Interactive comment on “Regional-scale brine migration along vertical pathways due to CO₂ injection – Part 2: a simulated case study in the North German Basin” by Alexander Kissinger et al.

Alexander Kissinger et al.

Received and published: 9 March 2017

We thank both reviewers for their valuable comments. We will reply to these comments in the following document:

Fig. 1.

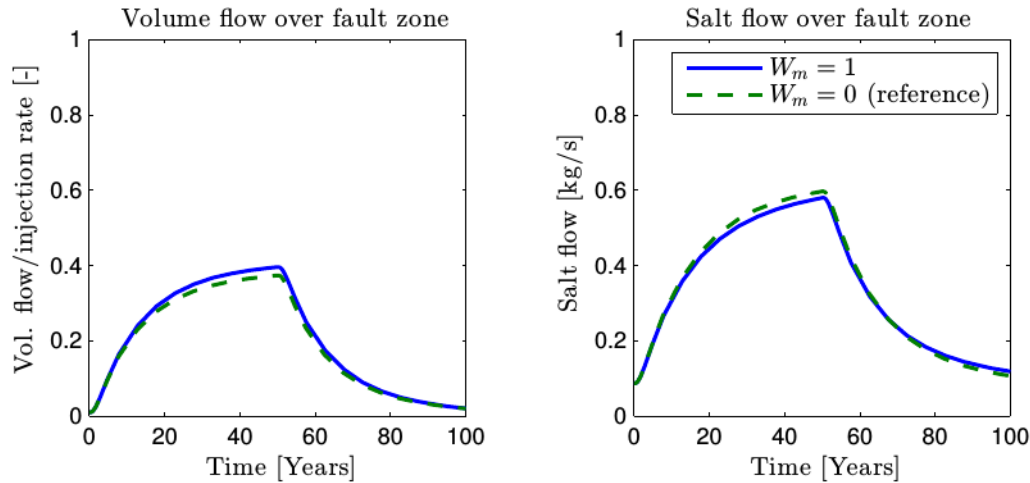
The effects of salt transport: The implementation of the discrete fracture model is such that per default a part of the degree of freedom's (DOF) volume is from the fracture and part from the matrix surrounding the fracture. We have looked at the effect when we neglect the matrix part of the volume at the DOF. This results in a reduced volume at the DOF and therefore a decreased DOF porosity (only fracture volume is active) and an increased transport velocity of the salt water being pushed upwards by the injection. This volume reduction can be as high as a factor of 6 (depending also on fracture and matrix porosities). We have attached a figure describing this comparison from the dissertation Kissinger (2016), see below. Please note that in the figure the "reference" case is not the reference case in this manuscript but the $W_m=1$ case corresponds to the reference case in this manuscript. Here we provide a short summary of the results for more details please consider Kissinger (2016). What we see is that as expected the salt transport into the shallow aquifers increases for the reduced porosity case (only fault zone porosity) compared to the default case (matrix and fracture porosity considered at the DOF). The overall volumetric leakage is also reduced which is a result of the increased weight of the fluid column inside the fault zone which leads to an increased resistance against upward flow. A similar behavior of increasing resistance and lower total mass flow rates due to brine being pushed upward in an improperly sealed abandoned well is reported by Birkholzer (2011). However, the increase in salt transport and the decrease in volumetric leakage we observe for our scenario are rather small.
